Southern California Edison Company

October 22, 1984

Subject: Docket No. 50-206  
Seismic Withstand Capability  
San Onofre Nuclear Generating Station  
Unit 1

ENCLOSURE

Figure 1 Turbine Building Math Model, San Onofre Unit 1

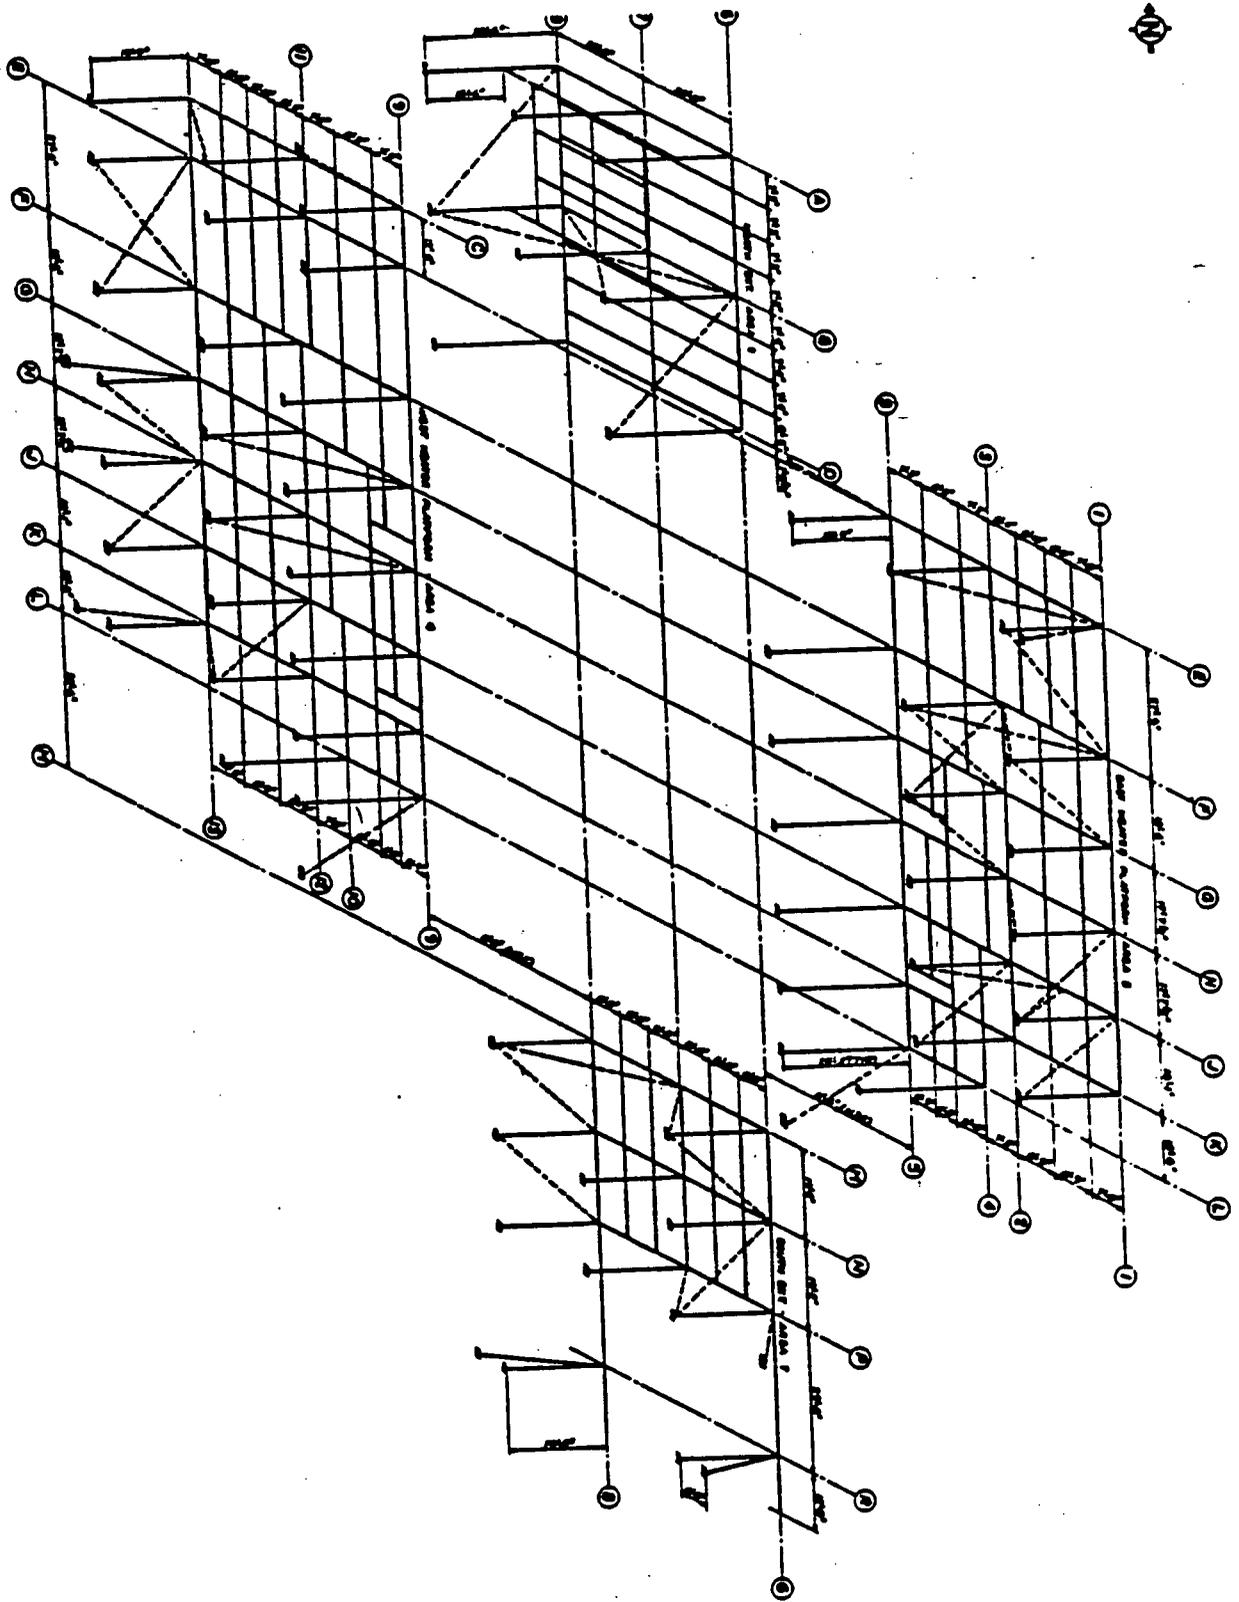
Question 1. Explain the basis for the judgement that secondary steel flexibility will not amplify the spectra that are used in piping analysis.

The design floor response spectra, as developed by Bechtel by time history methods and using detailed mathematical building models, are conservative. Impell regenerated some of these spectra using the FLORA code, using the same building models (see Figure 1). The FLORA code calculates response spectra using the direct generation technique.

Finally, the San Onofre Unit 1 turbine building model explicitly includes many of the interior steel structures. Thus, the flexibility of these steel structures is already accounted for in the design floor spectra.

Figure 6

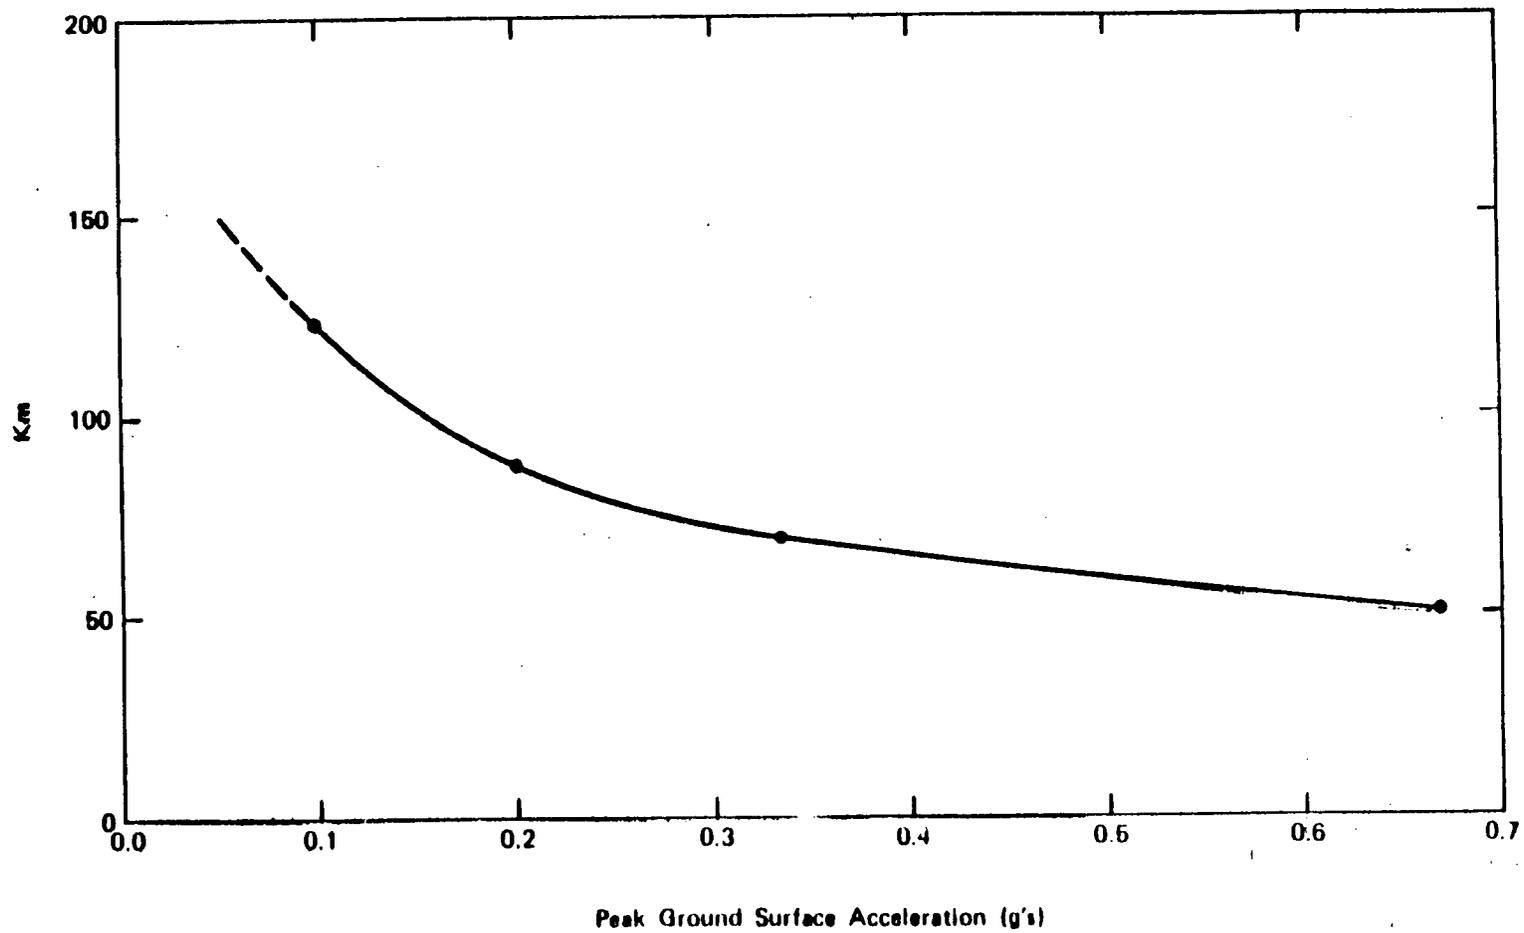
Question 2: Describe the technique used to generate floor spectra.

In addition, a review of soil behavior for a reduced level of earthquake was evaluated. A comparison of soil strains for the 0.33g and 0.67g earthquakes shows that the soil stiffness increases by about 25 percent when the level of earthquake is reduced to half its value for a horizontal earthquake. This is shown in Figure 6 attached. There is insignificant effect on soil strains for the vertical earthquake. To conservatively account for the higher soil stiffness for a lower level earthquake, the first mode peaks in the response spectra were shifted toward the high frequency end by 6 percent and 10 percent for the 0.5g and 0.4g horizontal earthquakes, respectively. Only the first mode peak was broadened, since this peak represents the soil mode. These results are given in Table 2, attached.
